Project	IEEE 802.16 Broadband Wireless Access Working Group <http://ieee802.org/16>		
Title	updating the text related to CSI under CX-Frame scheme		
Date Submitted	2007-09-07		
Source(s)	Wu Xuyong Huawei, Huawei Industry Base, Bantian, Longgang, Shenzhen, China 518129	Voice: +86-755-28976776 Fax: wuxuyong@huawei.com ,	
Re:	IEEE 802.16-07/019: Task Group Review: Working Group Draft P802.16h/D2c (2007-08-13)		
Abstract	AI to update the text related to CSI		
Purpose	To consolidate the 16h draft.		
Notice	This document has been prepared to assist IEEE 802.16. It is offered as a basis for discussion and is not binding on the contributing individual(s) or organization(s). The material in this document is subject to change in form and content after further study. The contributor(s) reserve(s) the right to add, amend or withdraw material contained herein.		
Release	The contributor grants a free, irrevocable license to the IEEE to incorporate material contained in this contribution, and any modifications thereof, in the creation of an IEEE Standards publication; to copyright in the IEEE's name any IEEE Standards publication even though it may include portions of this contribution; and at th

Figure h28—CSI parameters

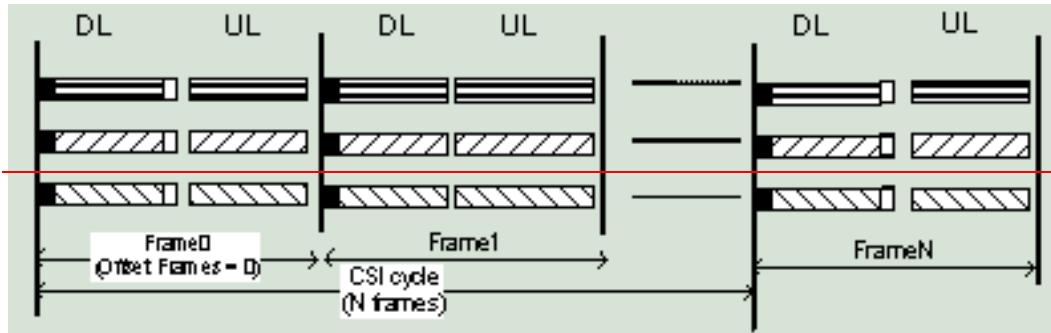
[Editor's notes: figure above should be update according to CX Frame structure, lack of proposed figure from C80216h-07_072r1.]

Figure h29—ICSI/OCSI occupation and timing allocation example

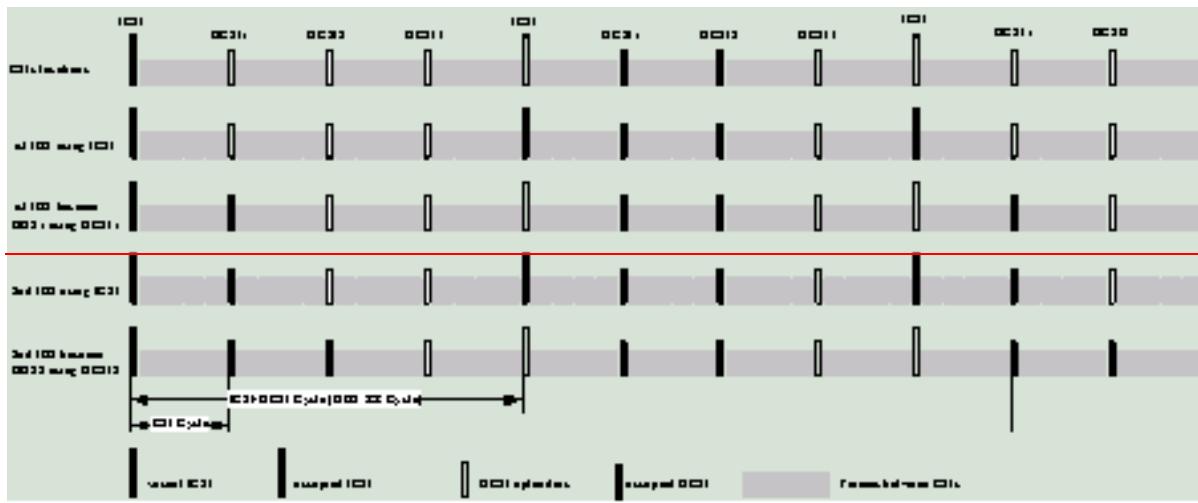
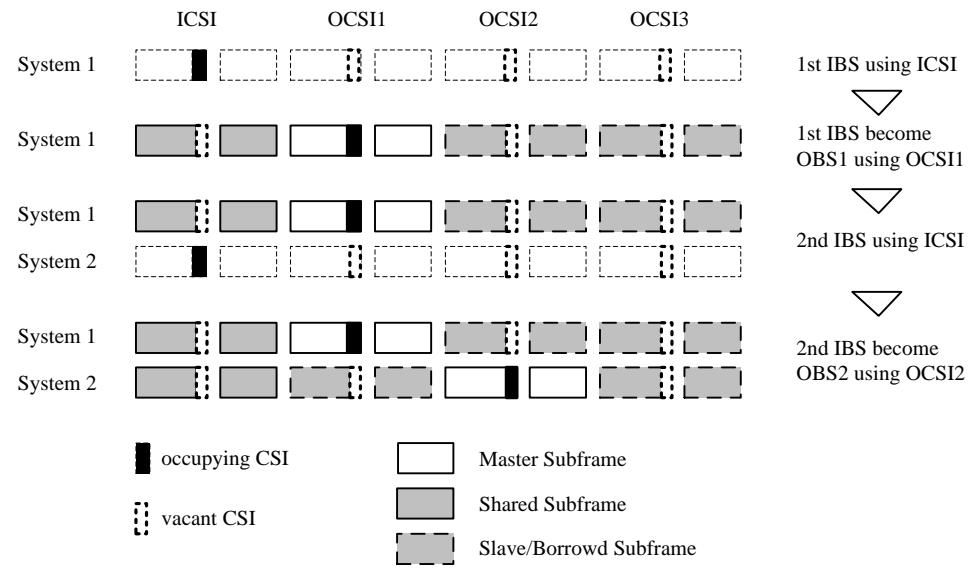
#Editor's notes: figure above should be update according to CX-Frame structure, lack of proposed figure from C80216h-07_072r1.]

Assuming CSI_Cycle = 2, aAn example of the timing indication is illustrated in **ICSI/OCSI occupation and timing allocation example**. The first IBS that enters an environment where none of the OCSIs is occupied. It uses the ICSI to broadcast coexistence signaling, then, since it has not detected any other CSI signal, it becomes OBS1 and chooses OCSI1 as the OCSI occupied for its system. Afterwards IBS2 starts up and uses ICSI to broadcast coexistence signaling. It finds its neighbor system, OBS1, occupying OCSI1, chooses OCSI2 as its OCSI and become OBS2 after the initializing phase. (see also **CSI scheduling**). IBS2 can be made aware of the occupation of OCSI1 by OBS1 either by detecting signald from the system OBS1, or by information received via CXP messages as feedback to the IBS2's broadcasting signals by the OBS1's SS's.

Figure h40—format example of ICSI/OCSI allocation MAP scheduling

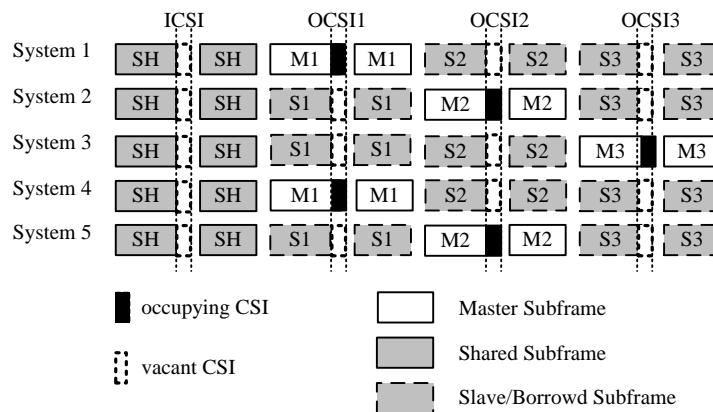
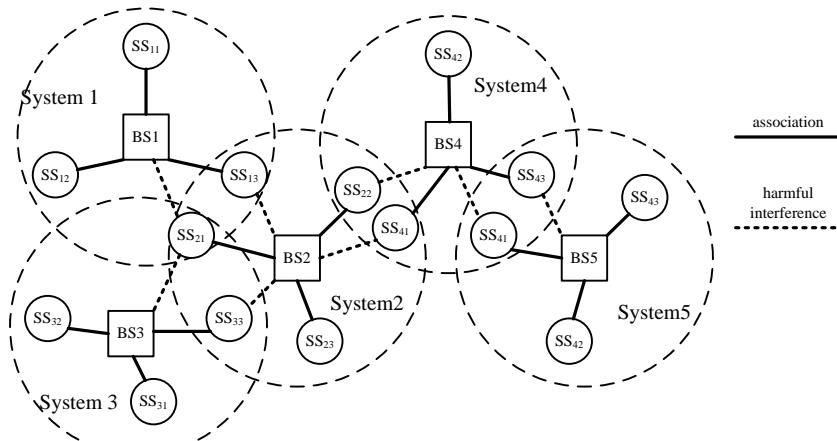
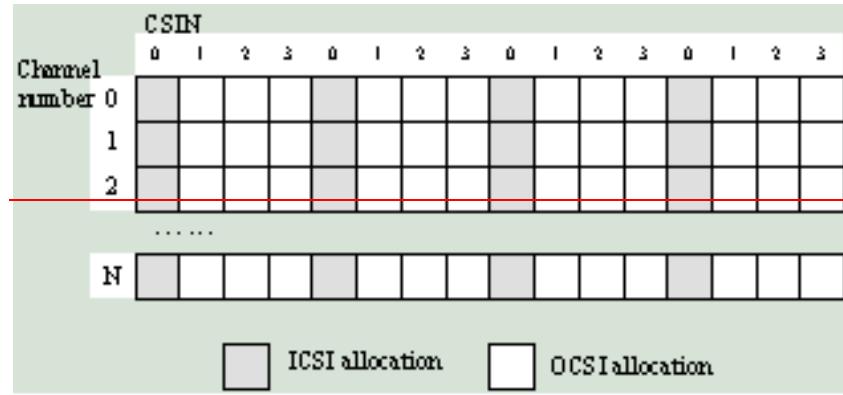
In Figure h34, CSIN 1 and 3 are used, but the text says a BS could choose 1, 2, or 3 which is incorrect.

Change the example to indicate that the BS with the map in Figure h34 could only choose CSIN 2. In fact, the example would be better if the BS chose one of the more lightly loaded channels like channel 1 or 2.

There is one ICSI for IBS in an CSI cycle, in the example figure below, each CSI cycle has 4 CSIs and CSIN 3 indicate the CSI numbers of the ICSI. The other CSI is left to the OBS as OCSI, as shown in Figure h 40. Every OBS needs to obtain an OCSI allocation in one CSI cycle, which is formed by multiple CX Frames. There are 4 CSIs in each CSI cycle, so that there are 1 ICSI intervals for the IBS and 3 intervals for up to 3 OBSs.=
